Field Service Information

GSM C650 – J931 connector detached.

Our Reference: SI39_8_2004

Subject: GSM C650 – J931 connector detached.

Blue dot is on the housing

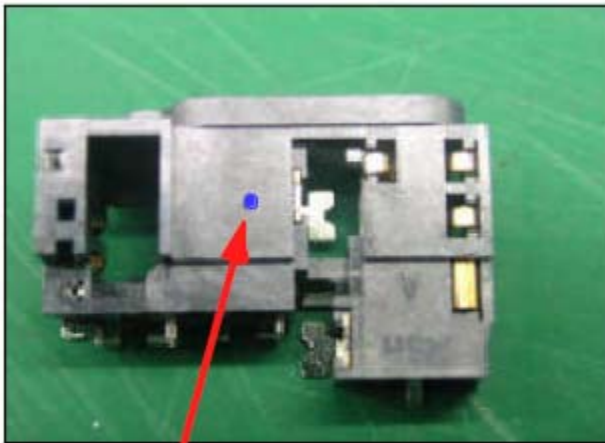
During MOL analysis of a C650 GSM product, service discovered some instances of the assembly J931 connector being completely detached from the board causing intermittent or no contact to the PCB. The problem arises from the solder tail co-planarity issue of Molex 3-in-1 connector causing poor solder connection between pad and solder tail tab during reflow.

Molex has concluded the analysis and improved their housing and tail forming design to prevent the solder tail bending issue. Molex started cross over of their production to the new housing and connector design, starting week 28. The new connector housing is marked with one blue dot (0970312J01). See photo below for illustration.

- 1) Disassemble the Housing Assembly and verify that the connector J931 (0970312J01) is detached from the PCB. Replace with a new connector that has the blue dot on the housing.
- 2) If the connector is intact, then proceed with normal troubleshooting techniques per customer complaint.
